## **SYDNEY HARBOUR BRIDGE CYCLEWAY NORTHERN ACCESS PROPOSAL REVIEW OF ENVIRONMENTAL FACTORS – NOVEMBER 2022 - NORTH SYDNEY COUNCIL RESPONSE**

## RE: SYDNEY HARBOUR BRIDGE CYCLEWAY NORTHERN ACCESS PROPOSAL - REVIEW OF ENVIRONMENTAL FACTORS – NOVEMBER 2022 - NORTH SYDNEY COUNCIL RESPONSE

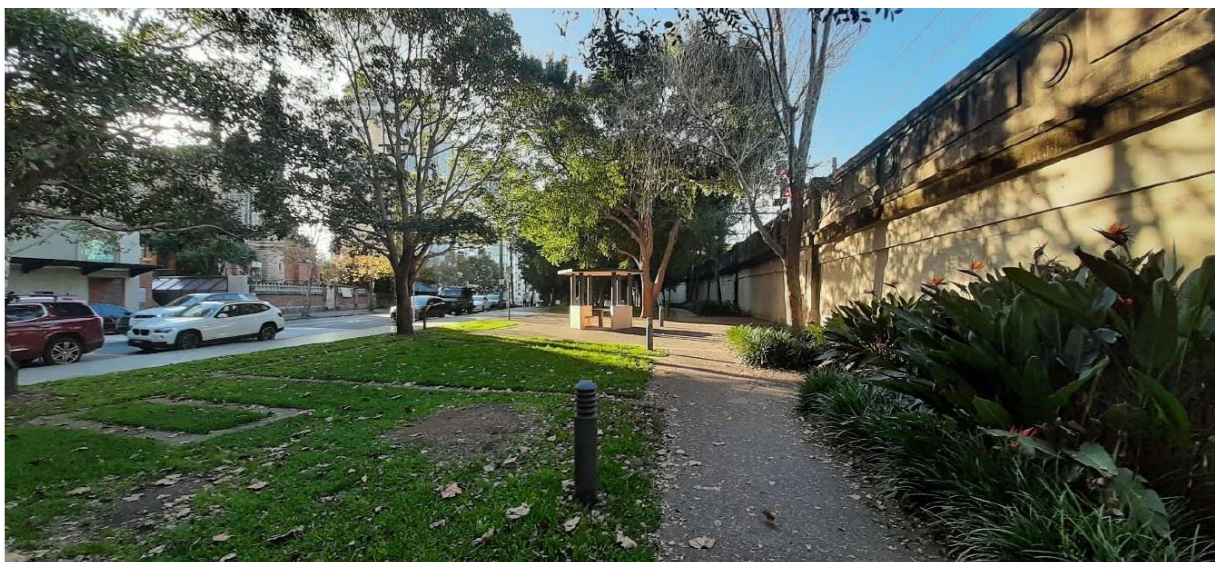
*Pedestrians enjoying the Bradfield Park North heritage walk along the Bridge wall. This path is to be removed and this view will be dominated by the under croft of the descending ramp structure. The gardens flanking the station will be removed and replaced with paving.*

*This view of the bridge wall will be blocked by the descending ramp structure which replaces the path on the left. The grass in the foreground will be replaced with a concrete path.*

*The ramp descends on the right of the image, replacing the heritage walk pathway. The rotunda in the centre of the park is to be removed. This is the only location in Bradfield Park North that receives late afternoon Winter sunlight, as pictured in the centre of the image.*

*This view of the Milsons Point Station Entrance will be severely compromised by the ramp structure.*

*The ramp imposes on and detracts from this view of the station forecourt area.*

*The ramp obscures this view of the Burton Street Tunnel Archway*

Extract from REF document, showing trees proposed to be removed, and trees to be pruned

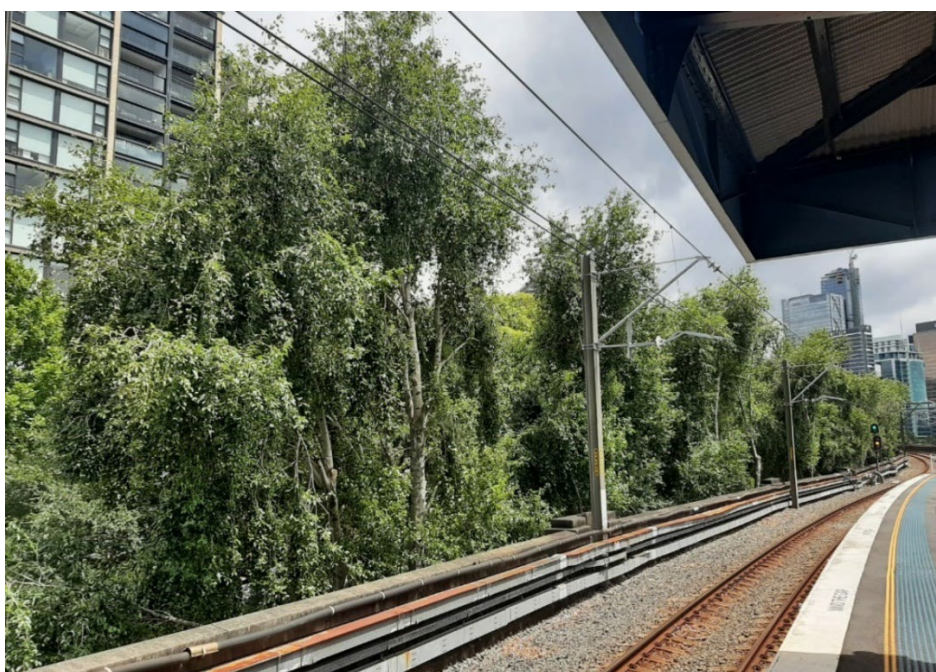
The removal of the poplar trees along the heritage walk is not supported: these trees were planted as part of the 2003 upgrade works to interpret the original Bradfield poplar plantings, designed to emphasise the expressed pilasters of the Bridge Approach Walls. These trees provide an important visual buffer from the residences on the west side of Alfred Street to the railway and Bradfield Highway to the east. These trees also ameliorate the view from the train-line of the wall of buildings fronting the west side of Alfred Street, as shown in the images overleaf:

The removal of the palm tree within the Lavender Street roundabout is not supported: this planting is much loved as a landmark by the local community. The proposed trimming of the fig tree on the corner of Burton Street and Alfred Street South for construction access is not supported: this tree provides shade, and its canopy embraces the corner of the Burton Street Shared Zone, framing the view of the Bridge heritage features beyond. The proposed trimming of the Chinese Elms adjacent to the cycleway is not supported: these trees provide much needed shade and amenity for park users.

Accordingly, Council objects to the proposed removal and trimming of trees as proposed by TfNSW. Further, it is not clear from the information provided as to whether other trees in the park may also be affected, either during construction or permanently as part of the work (for example trees needing to be continually pruned clear of the elevated cycleway structure). It is also concerning that the arborist report included in the REF appendices is marked 'preliminary'.

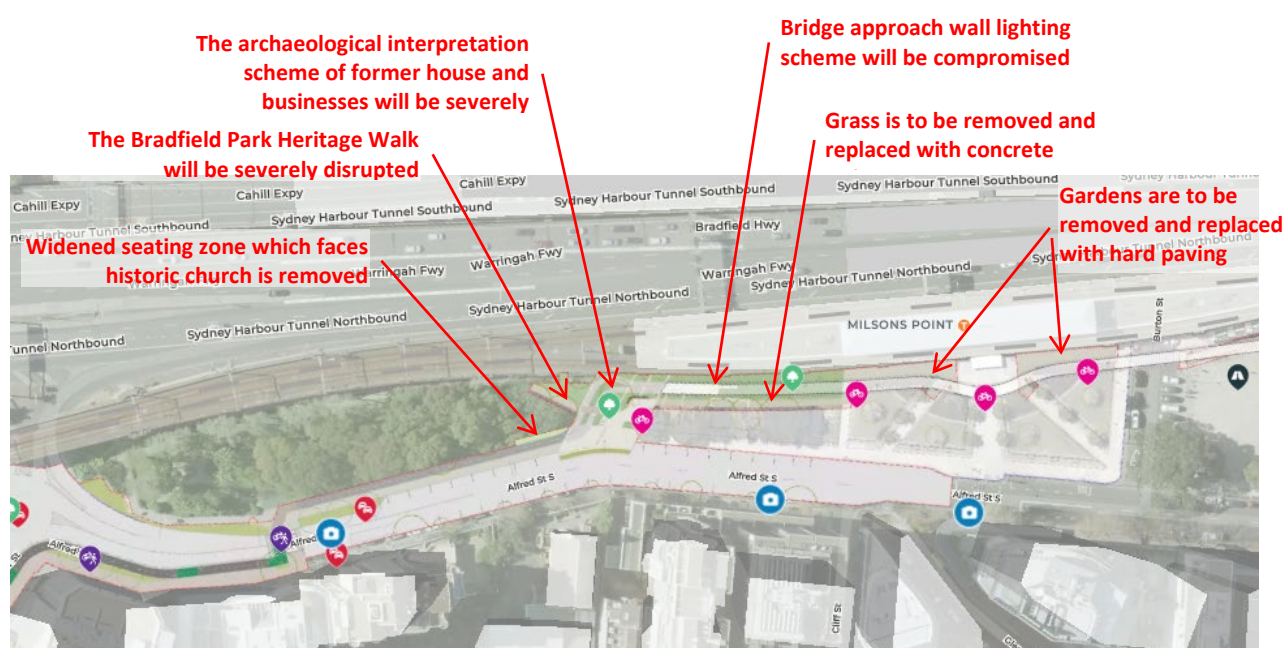
*Under the TfNSW plans, the grassed area in the foreground of the image above is removed and replaced with a concrete pathway. The existing pathway to the left of image is removed, becoming under-croft space to the ramp.*

The section of grass proposed to be replaced by concrete path is the most verdant, healthiest area of easily accessible grass in the whole of Bradfield Park North. Whilst the station forecourt radial layout also features well-established grass areas, these areas are not accessible. The proposed grass to be removed also provides a visual lead-in between the forecourt grass areas and the park further to the north. Accordingly, the proposed removal of grassed areas and replacement with concrete pathway is opposed.

The design and location of the ramp will also create difficulties to establish the proposed garden areas beneath the ramp due to the rain shadow effect. It will also create maintenance difficulties for Council staff who would need to access the constrained spaces beside and under the ramp.

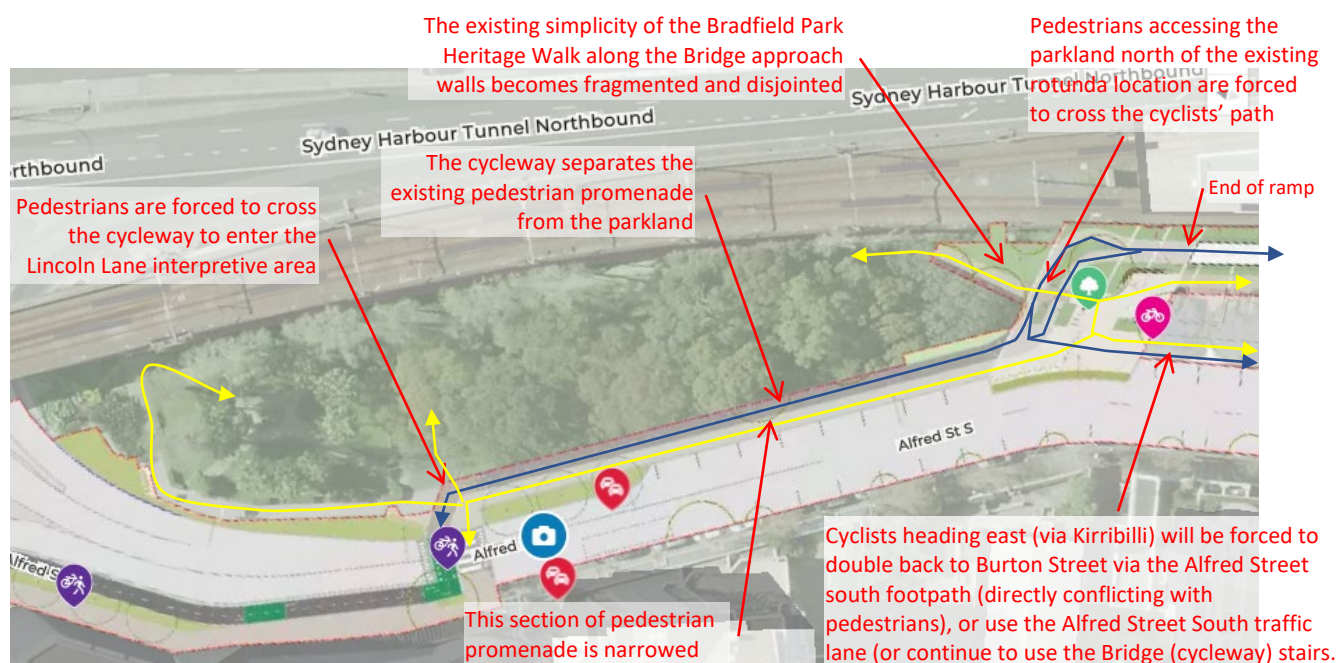
The pedestrian path along the Bradfield Park North frontage, south of the proposed pedestrian crossing is to be narrowed to 2.25 metres from approximately 3.5 metres. This reduction is considered inadequate for the pedestrian flows experienced and is contrary to the principles of the master plan to which Council worked for the 2003 design upgrade, which sought to provide a generous footpath along the frontage of Bradfield Park north as part of the grand promenade down to the Bridge and harbour foreshore.

Furthermore, pedestrians will be corralled between the kerb and the designated cycleway, the latter which runs parallel to the path between the path and the parkland. This is an unacceptable urban design outcome and a poor outcome for the many pedestrians that use this path daily. The poor outcomes for pedestrians, and park users generally are further exacerbated in that pedestrians are forced to cross the cycleway at critical points to enter the northern part of Bradfield Park North (north of the existing Rotunda, which is to be removed under the TfNSW proposal). This creates an uneasy relationship between the parkland and pedestrians who will no longer have unfettered access along the park frontage.

Section of interactive map showing northern end of Bradfield Park North marked up with the poor outcomes for pedestrian / park users under the TfNSW ramp / cycleway proposal.

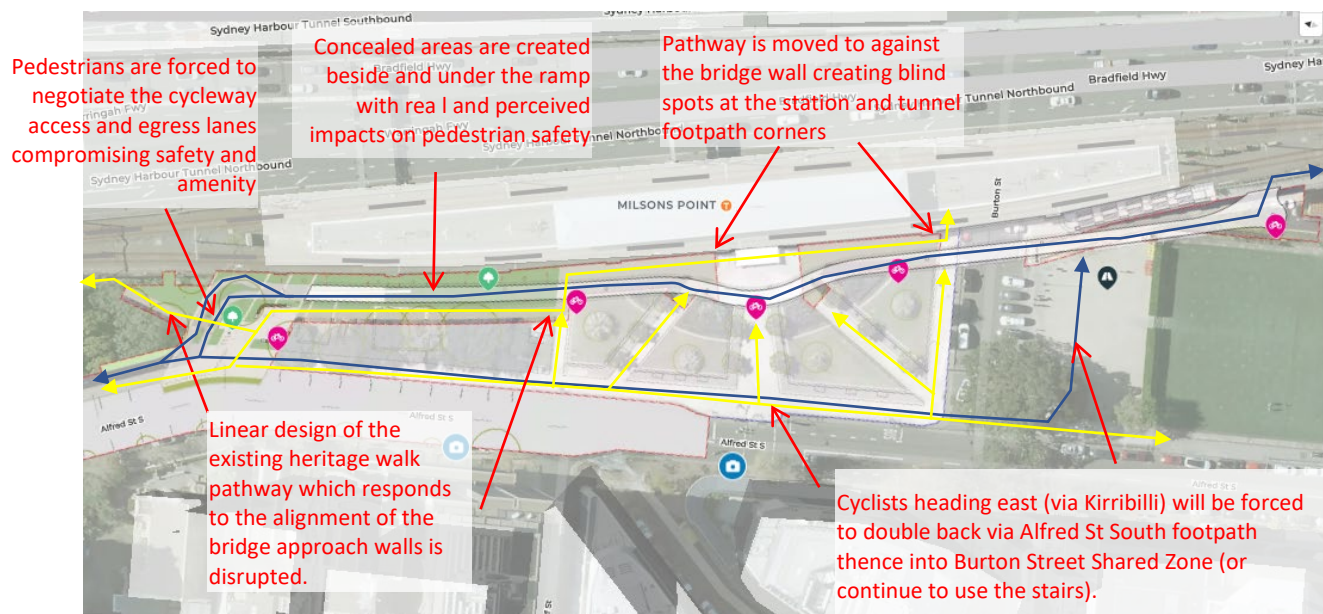
In addition, the existing seamless pedestrian connection between the heritage interpretation paved area representing the former Lincoln Lane, a key feature of the 2003 upgrade and heritage interpretation scheme developed in liaison with the NSW Heritage office, will be severed by the cycleway, which cuts between this area and the pedestrian footpath. This is a poor urban design outcome and an equally unfortunate outcome for both pedestrians and park users.

Cyclists heading east via Kirribilli will also be forced to double-back to the Burton Street Tunnel underpass via the Alfred Street south footpath, bringing them into conflict with pedestrians on the journey south to Burton Street, or to use the Alfred Street South traffic lane, or continue to use the Bridge (cycleway) stairs. Currently cyclists heading east disperse onto the Burton Street Shared Zone and make their way directly through the tunnel underpass to the Kirribilli side.

Removal of the garden areas outside the station entrance (as referred to under Landscape Character & Amenity Impacts) and the associated proposed placement of the main north-south pedestrian against the bridge approach wall, rather than having a separation as exists now, will create potential blind spots where pedestrians enter exit the station concourse and the northern side footpath of the Burton Street tunnel. The ramp as designed will also create concealment areas beneath the ramp and between the ramp and the bridge wall. These negative impacts are contrary to the principles of Crime Prevention Through Environmental Design (CPTED) and will make pedestrians feel unsafe, further diminishing the values of Bradfield Park North as public open space.
